Technical Service Bulletin

Cobra Moto, LLC

TSB1118 Radiator Mounting CX65 2017 - 2018

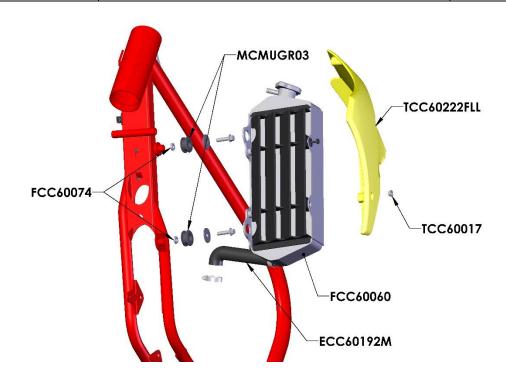
Some customers are having issues with radiators leaking prematurely on 2017 – 2018 CX65.

Mounting the radiator less rigidly and taking strain off the bottom hose spigot with a kit of parts, FKC60002. Parts included in the kit are;
